Product Change Notification (PCN)

PCN #: 3C-2024

Date: Mar 11, 2024

5.1 Assembly Part Number Changes (Modem Label)

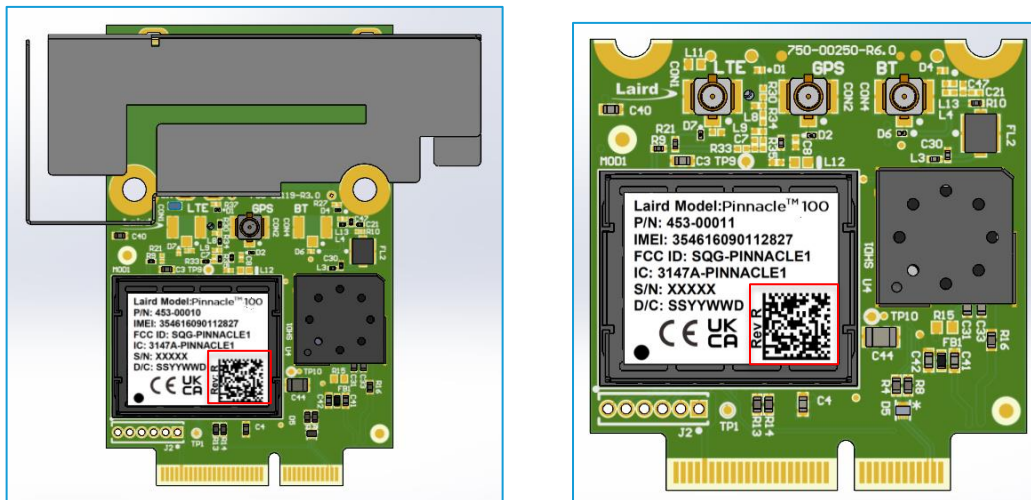
- Revision changes available as revision number printed and within the barcode.

5.2 Top Level Part Number Changes (Packaged Kits)

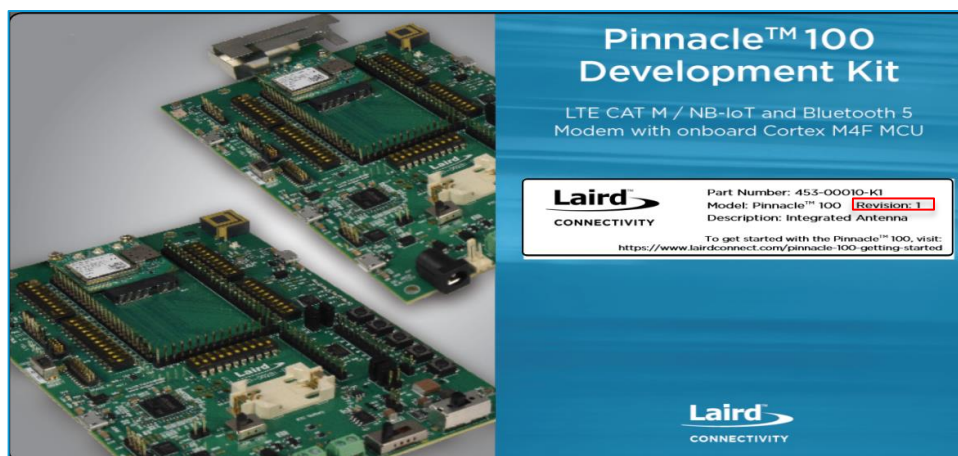
- The product revision level is defined as a revision number printed on the content label for all kits. The specific kit part number and revision can be found on the label within red square area, as highlighted below.
